Case Name/ Number: The Enclave at Todd Creek / PRC2025-00002

Development Review Team Comments – 1st Review

Project Name: The Enclave at Todd Creek

THE ENCLAVE AT TODD CREEK
ADAMS COUNTY, COLORADO
PROPOSED DRAINAGE PLAN
PREPARED FOR:
PEAK 3 PROPERTIES, LLC

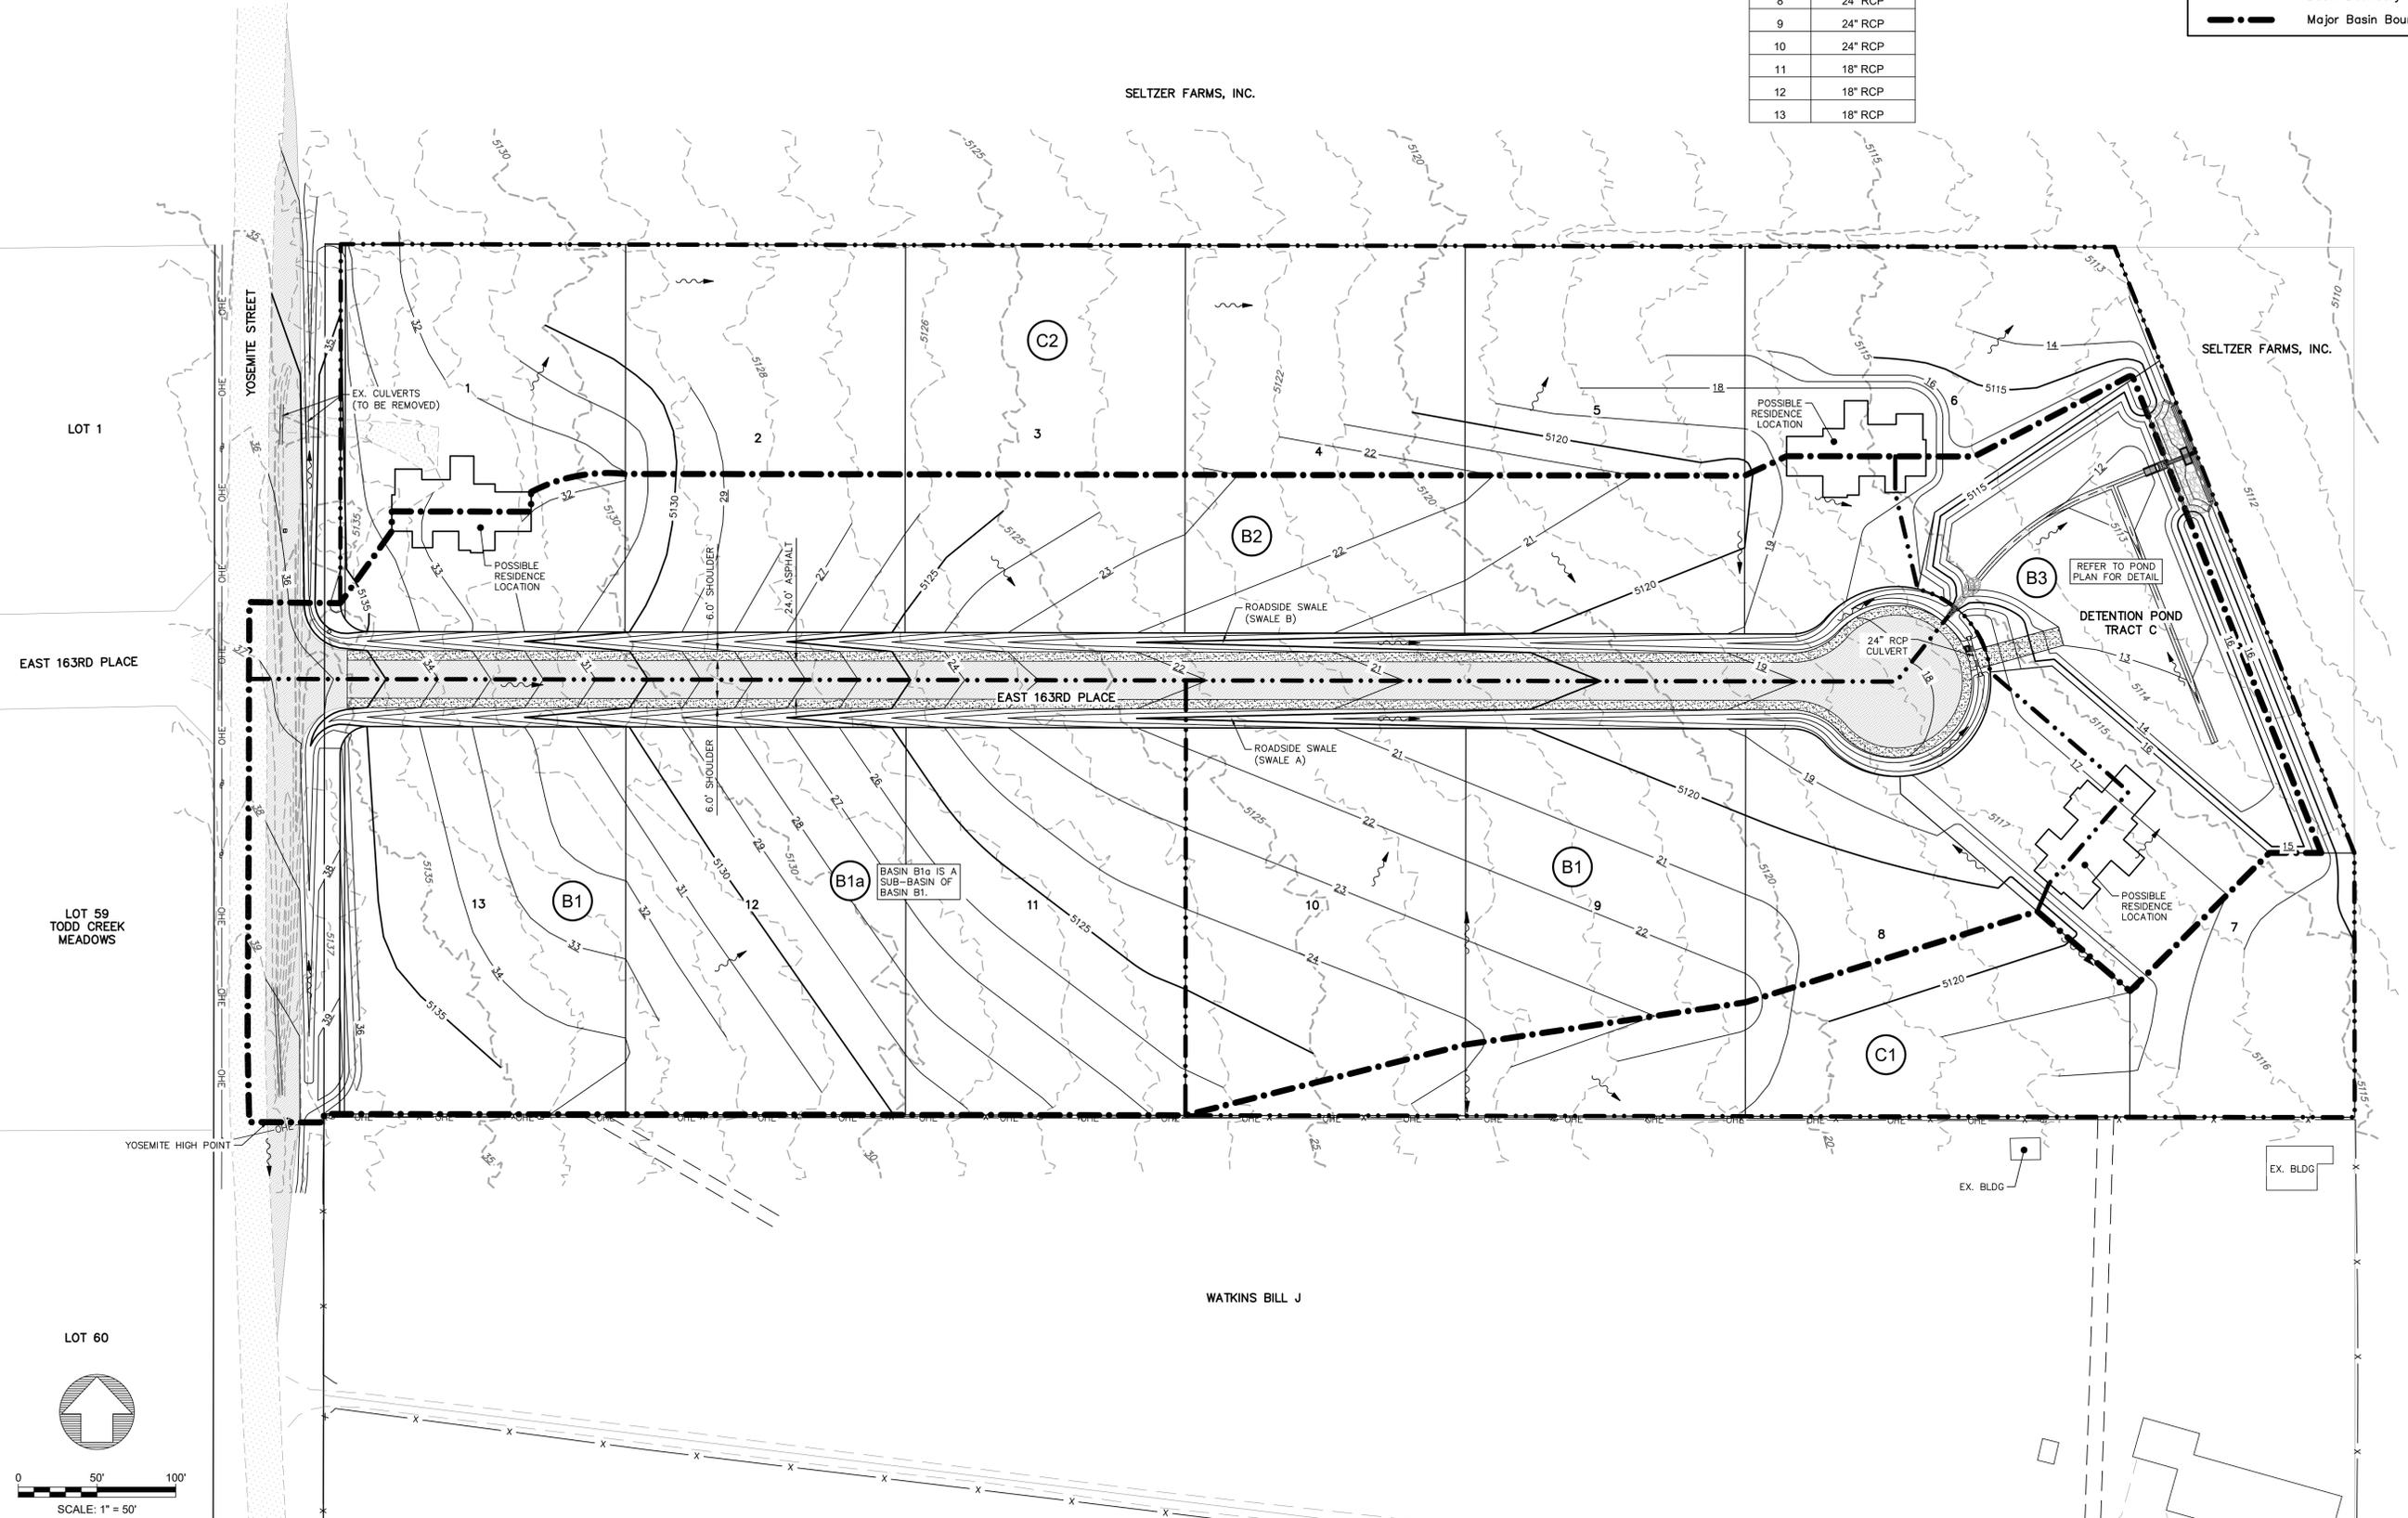
ENG15: The proposed detention pond outfall is not acceptable. The pond cannot be drainage as a point outfall discharge onto a neighboring property as this configuration can cause damage to the neighboring property.

ENG16: The proposed detention pond design is required to meet all the criteria of the Mile High Flood Districts (MHFD) Criteria Manual. This will require the inclusion of a forebay and micropool within the pond. These features are not currently shown in the preliminary engineering documents.

RESPONSE : A flow spreading weir was added along the eastern property line to remove the point outfall discharge.

RESPONSE : A forebay and micropool were added to the preliminary design of the detention pond. The forebay and micropool will be designed with final construction plans.
